Product Advisory

PA-664

Models Affected: L13i, LT, LTM, TL, and TM Aerials

SUBJECT: 4 - Function Stick Control (Assemblies 483417, 485144, 617812, and 483577)

Figure 1 - Cover removed to show components

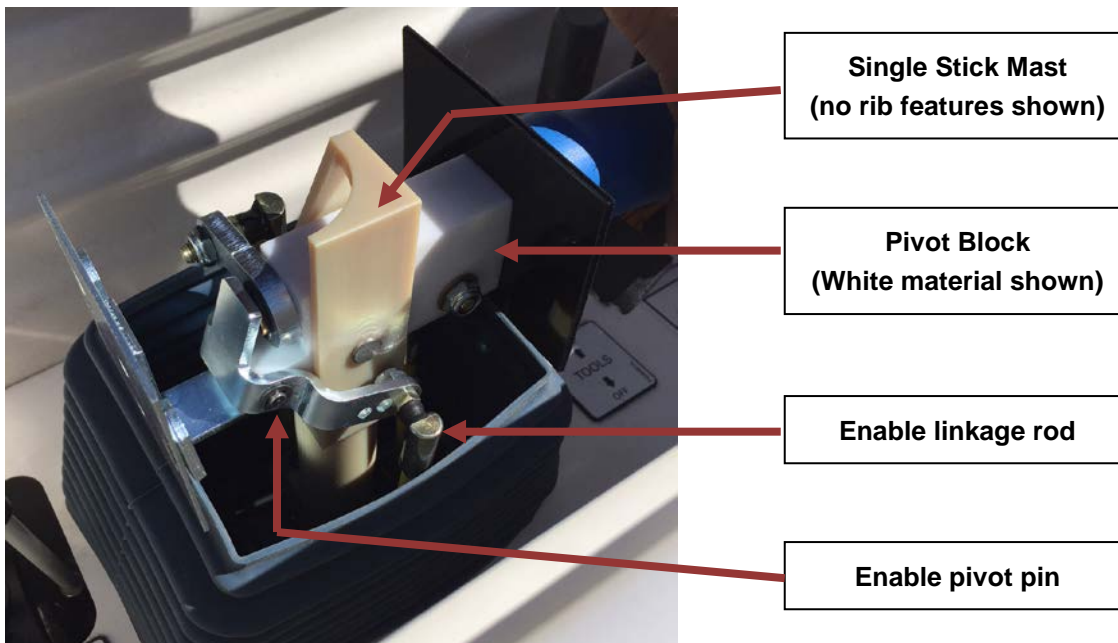
1. Remove the two plastic screws from the plastic cap, opposite side from the handle, of the single stick and remove the cap to gain access to the components shown in Figure 1. Inspect the Pivot Block and the Single Stick Mast for cracks.

Figure 2 – All possible pivot blocks

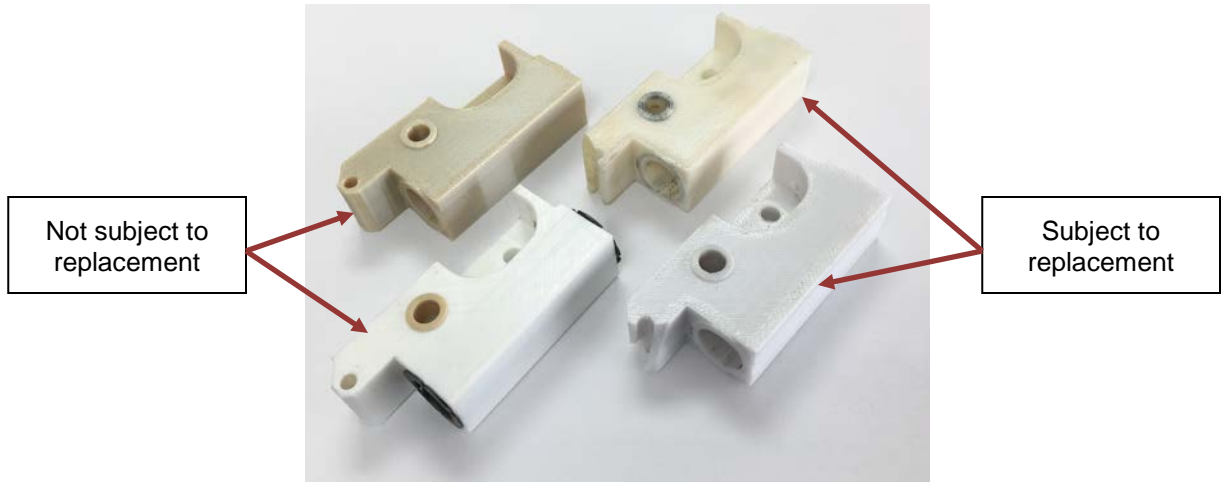
2. Inspect the pivot block material. Pivot blocks that are white in color, which have been manufactured with the bushing features as part of the base material, are subject to replacement. See figure 2. Pivot blocks that are tan in color or if the bushings are separate components from the pivot block (See figure 2a), are not subject to replacement.

Figure 3 – Ribbed mast on left and non-ribbed mast on right

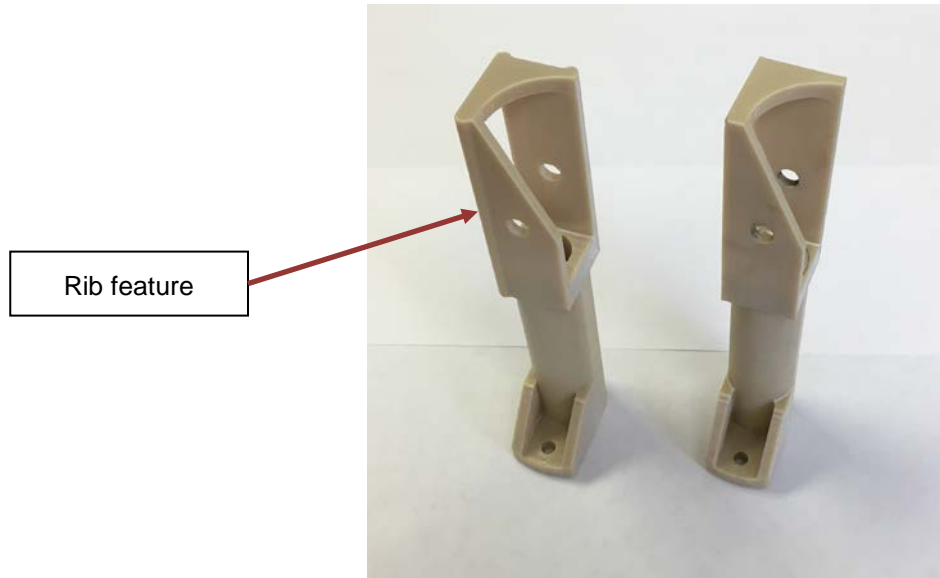
3. Inspect the single stick mast for the rib features shown in Figure 3 and Figure 4. Masts that do not have the reinforcement rib features are subject to replacement. Masts that have the reinforcement rib features or are black or yellow in color, as shown in Figure 5, are not subject to replacement.
